March 13, 2015

RE: IRP Manager (and Select CAC Comments) Regarding the California Regional Water Quality Control Board Lahontan Region Cleanup and Abatement Order (CAO) No. R6V-2015-Prop, Issued on January 21, 2015.

FIGURE 3

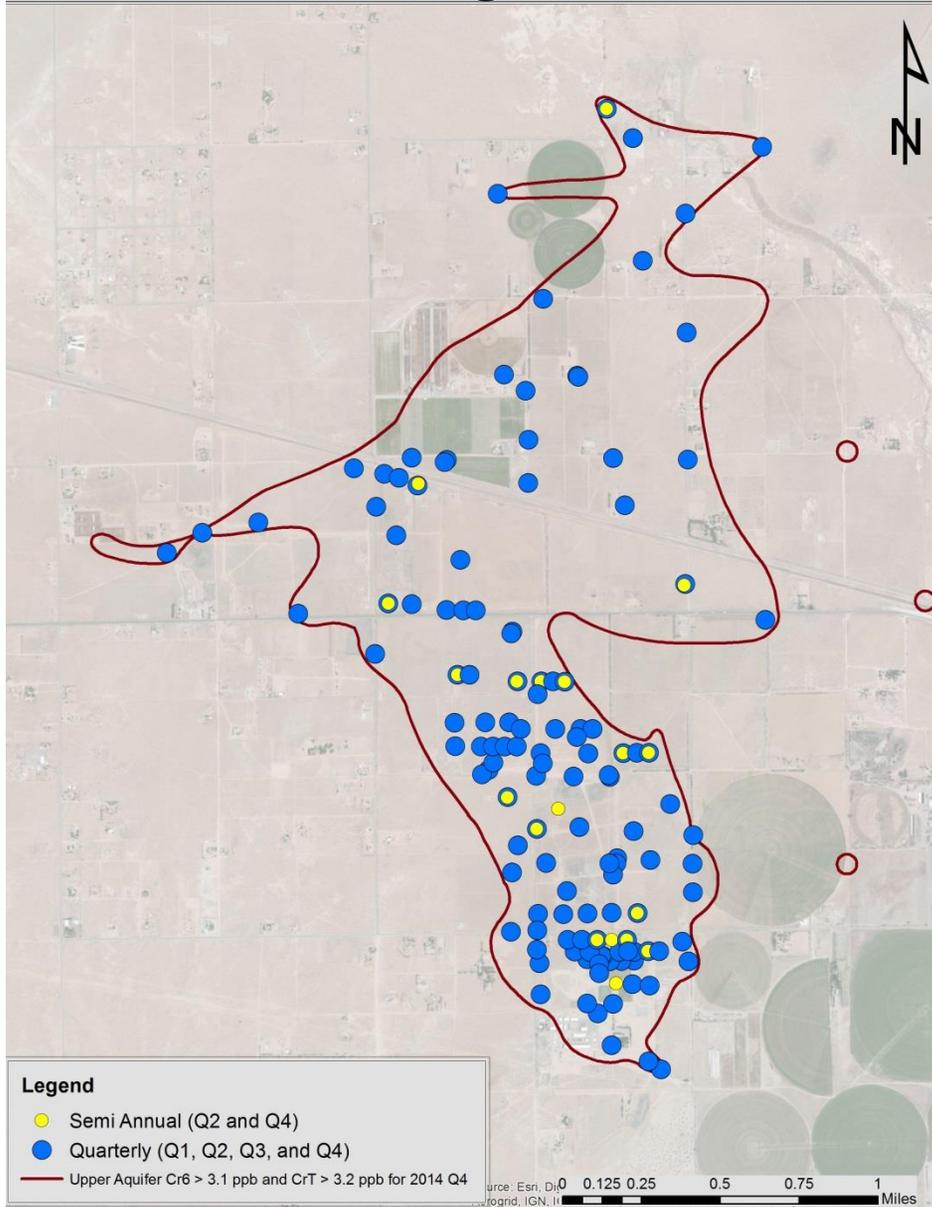
- Clarification sought on section C.1.b. *“Semi-annual sampling in the second and fourth quarter of each year at multi-depth monitoring wells showing the second **and third** highest hexavalent or total chromium detection above maximum background levels as of fourth quarter 2014.”* Do the words *“and third”* require to be deleted in section C.1.b since section C.1.c. discusses “the third highest hexavalent detections”?

Figures 3 to 6 describe the IRP Manager's interpretation of the Water Board's proposed monitoring well sampling program for the southern plume area. **Figure 3** shows the monitoring wells that fall under requirements I.C.1 in the MRP for monitoring wells greater than or equal to maximum values as of the fourth quarter, 2014. A total of **170 monitoring wells** fall into this category and consist of **132 quarterly** and **38 semi-annual** monitoring wells. **Figure 4** shows monitoring wells that fall under requirements I.C.2 for wells with concentrations less than maximum background values as of fourth-quarter, 2014. A total of **132 monitoring wells** fall into this category, consisting of **30 quarterly** and **102**

FIGURE 4

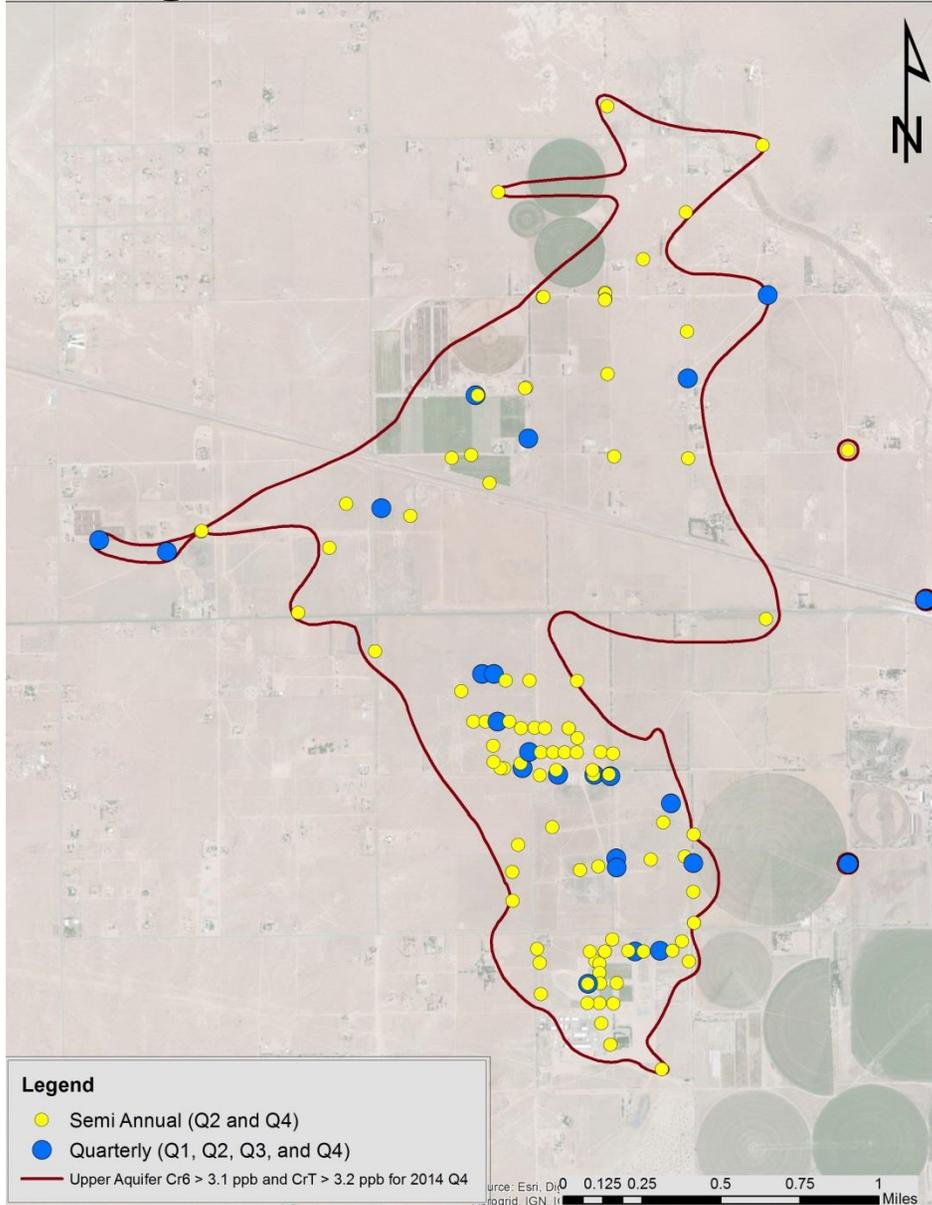
semi-annual monitoring wells. Monitoring wells that are under quarterly sampling in accordance with requirement I.C.2 of the MRP are defined as “unstable⁷”.

FIGURE 5

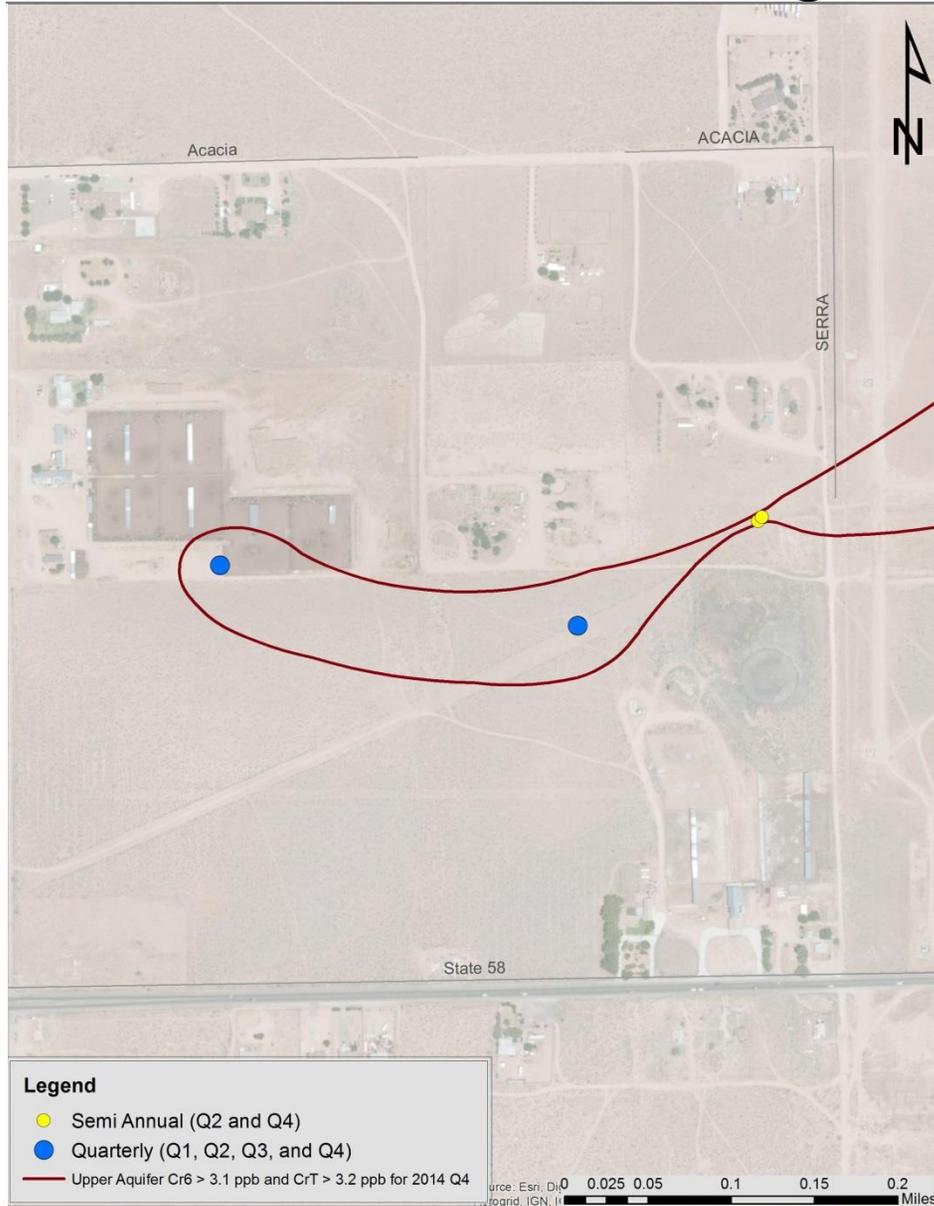
Figure 5 shows monitoring wells under requirement I.C.3 for the “Western Finger” located west of Serra Road. **7 monitoring wells** fall under this category consisting of **2 quarterly, 2 semi-annual** and **3 annual monitoring wells**.

FIGURE 6

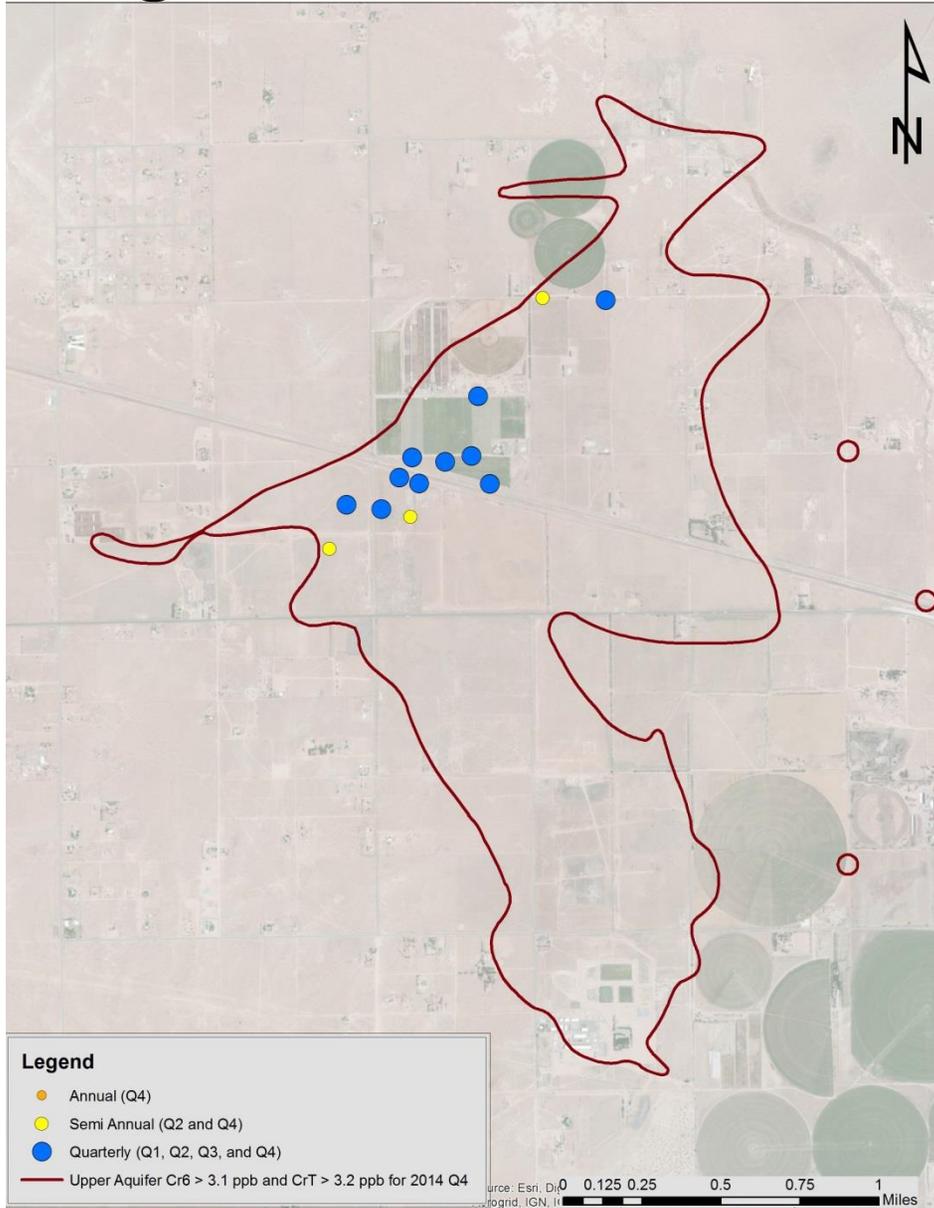
Figure 6 shows the monitoring requirements for the lower aquifer in accordance with I.C.4. A total of **13 monitoring wells** are included, consisting of **10 quarterly** and **3 semi-annual** monitoring wells. These maps, prepared by the IRP Manager's staff indicate that the southern plume will be comprehensively monitored via the Water Board's proposed monitoring plan.

FIGURE 7

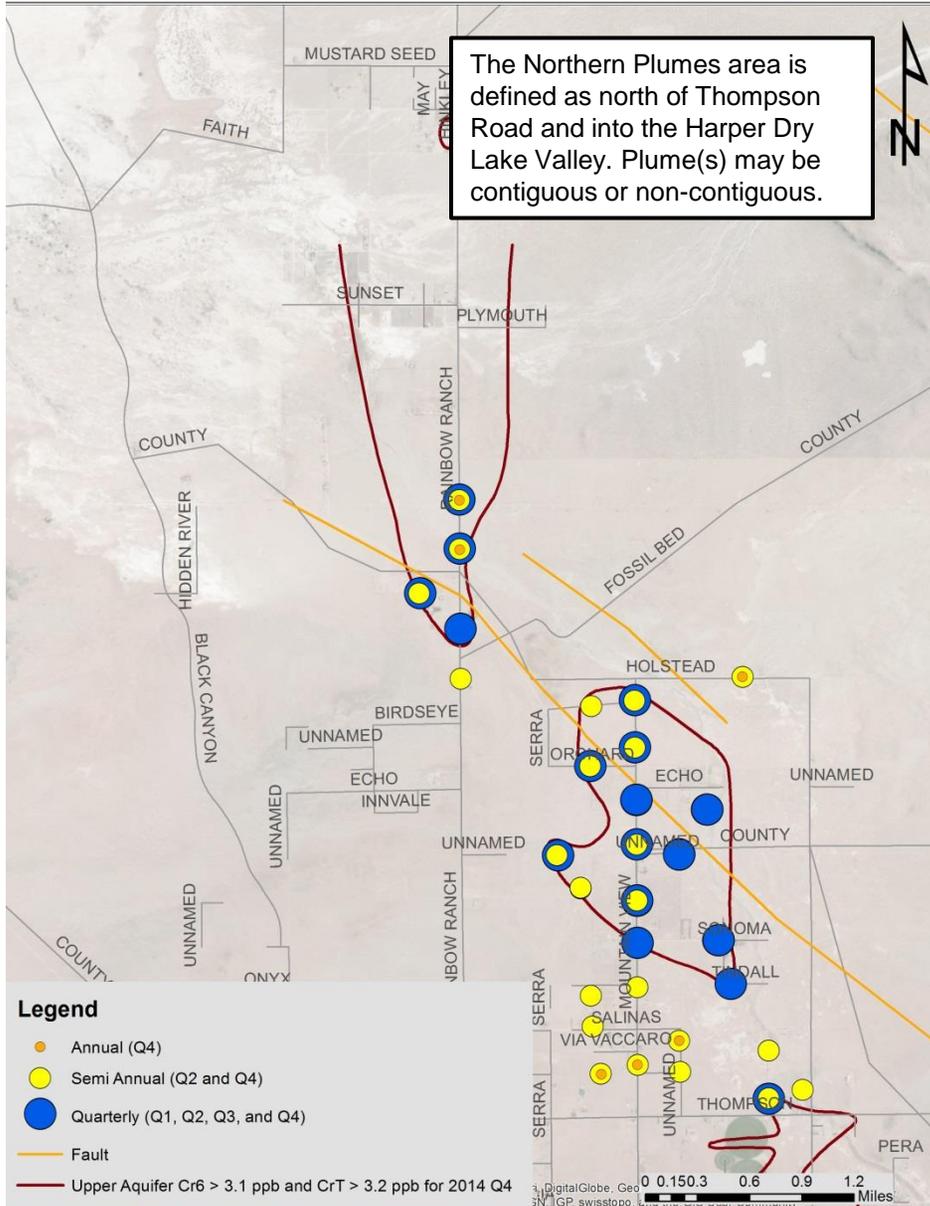
- What is the minimum sampling frequency for monitoring wells in the northern plume area?;
- What is the general sampling reduction plan for monitoring wells discussed in Section I.D.4 (e.g. quarterly → semi-annual → annual)?;

Figure 7 shows the IRP Manager's interpretation of the sampling program in the Northern Plume(s) Area.

FIGURE 8

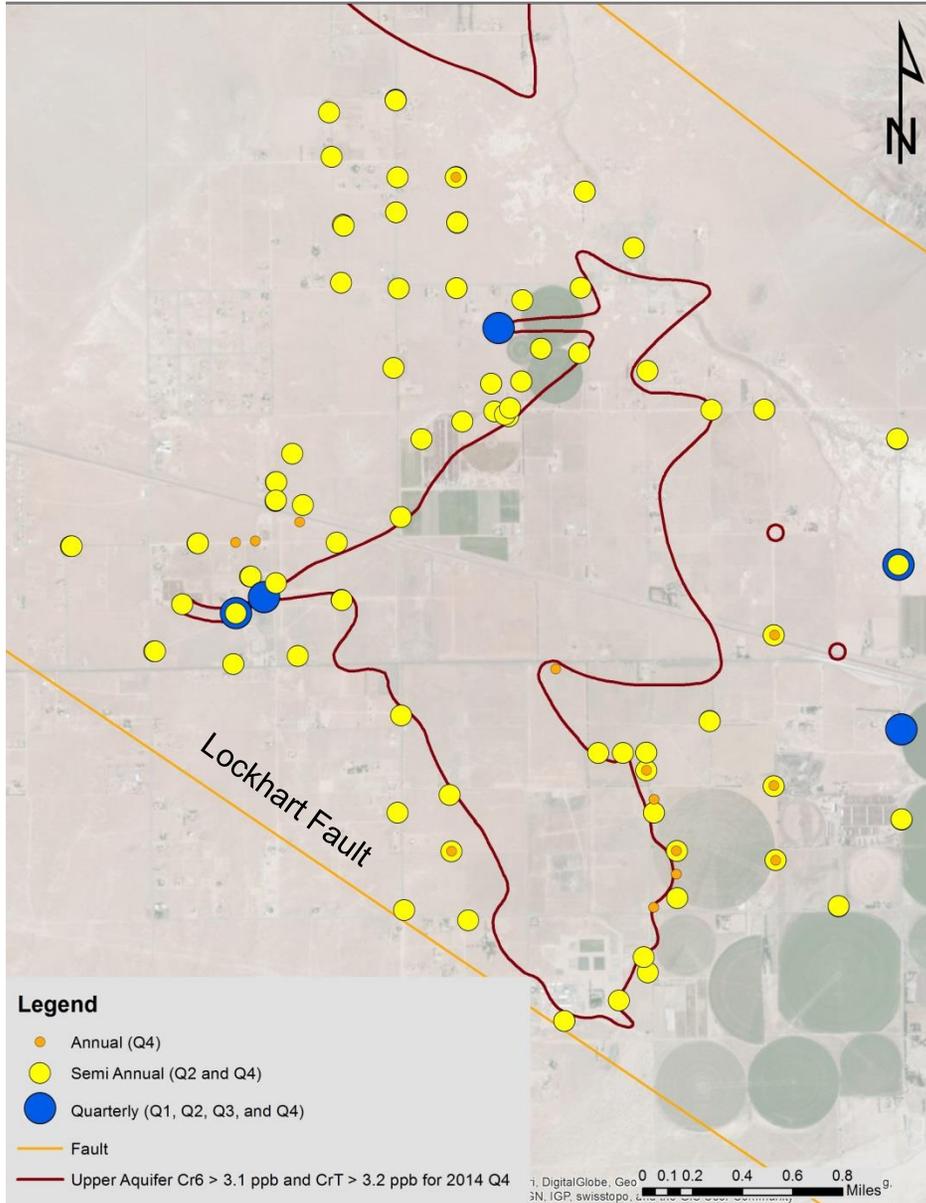
Figure 8 shows the monitoring wells that are under requirement I.E. Under I.E there are **161 monitoring wells**. They consist of **5 quarterly, 128 semi-annual** and **28 annual** monitoring wells. Our suggestions regarding

Section I.E is that statistical trends (e.g. Mann-Kendall test) should be a component to determine the sampling frequency in this area.
